ELEVATION - WEST - VIEW 2

EAST/WEST VIEWS OF ALPINE HOTEL

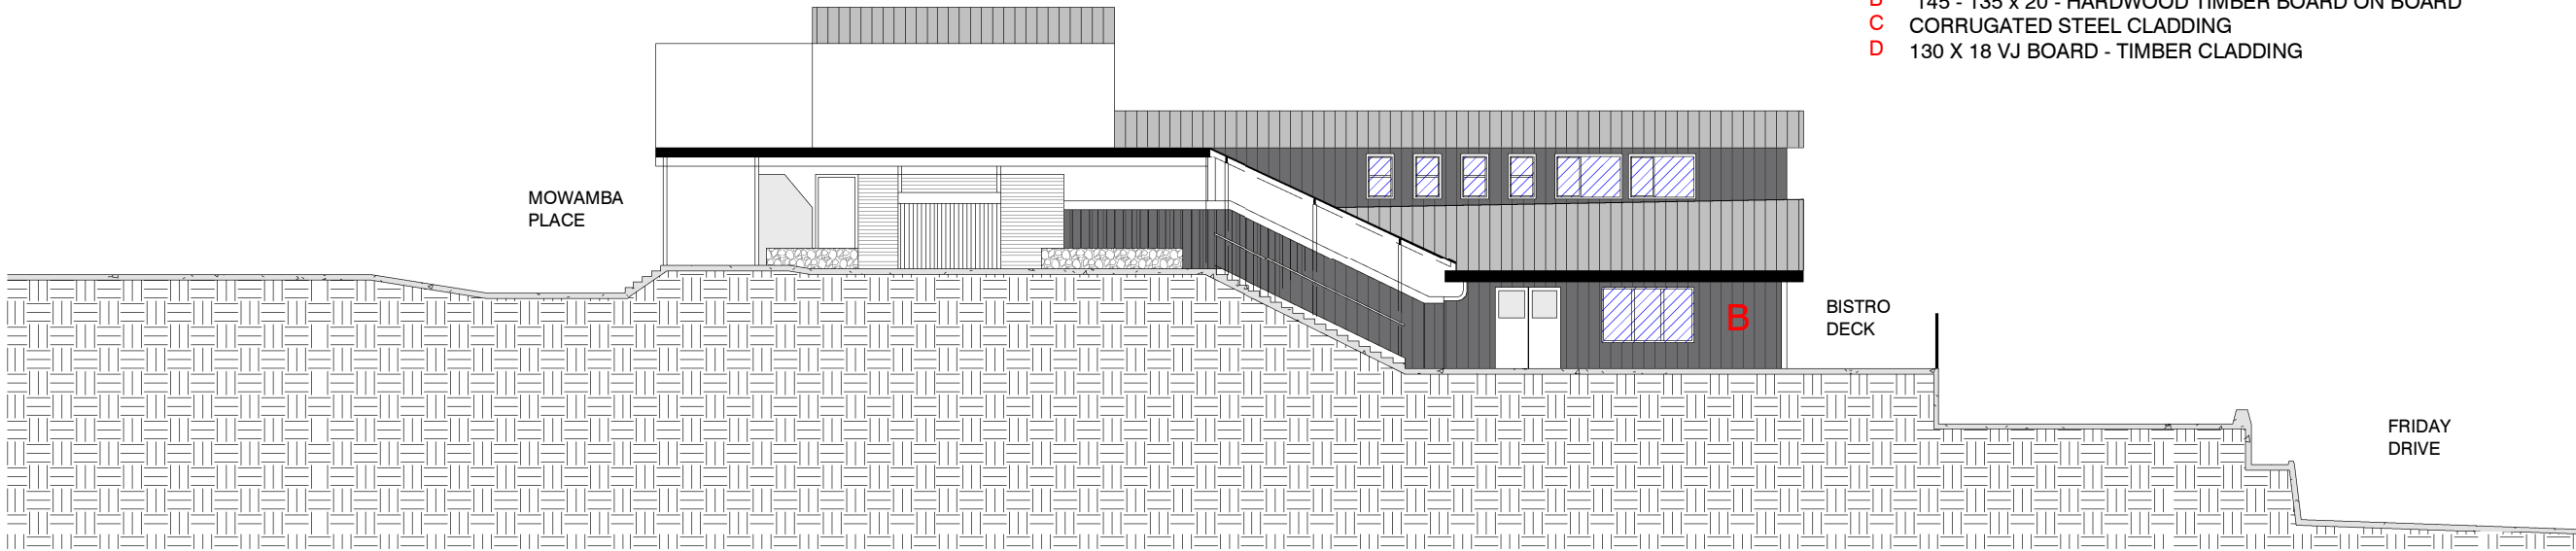
- REPLACE EXISTING HARDWOOD CLADDING WITH  
NEW COLORBOND V25 PROFILE METAL CLADDING - MATERIALITY AND COMPLIANCE TO BE ENSURED PRIOR TO CONSTRUCTION CERTIFICATE.  
EXTERNAL PAINT FINISH TO MATCH EXISTING BASALT COLOUR.
- EXISTING WINDOWS LOCATED IN CLADDING  
WINDOW TO BE REPLACED IF LOCATED WITHIN PROPOSED NEW CLADDING
- NEW WINDOWS WILL COMPLY WITH AUSTRALIAN STANDARDS 3959 CONSTRUCTION OF BUILDINGS BUSHFIRE-PRONE AREAS
